# ETHOS URBAN

## Request for Additional Information

Edmondson Park Frasers Town Centre  
Residential Precinct 1 (Stage 1 Built Form)

01 February 2018 | 15895

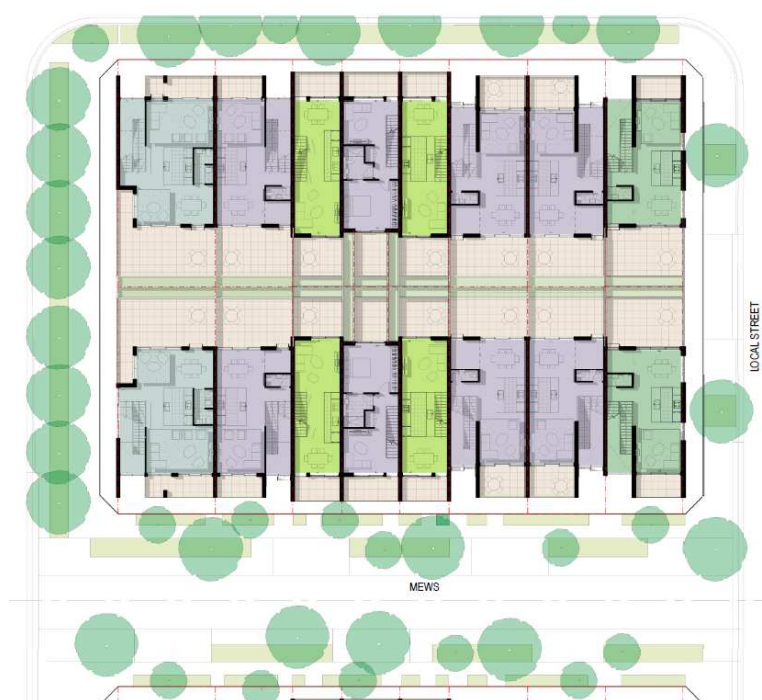
***The proposed development does not provide a high quality level of amenity, especially where there is significant concerns raised over privacy between rear facing dwellings; visual and acoustic. It is advised that the separation distances between rear facing dwellings be increased to ensure a high level of amenity, especially ensuring adequate privacy is provided for future occupants.***

A comparison of the approved illustrative design scheme and the proposed layout of the Townhome product is provided at **Figure 3** and **Figure 4** that demonstrates the design remains consistent with that approved by the Concept Plan.

Amendment to the separation distances, including increasing them beyond the requirements of the Design Guidelines would be a contravention of the Concept Plan and prevent Frasers delivering the yield and housing (including affordable housing) at the density approved and required by the Concept Plan.
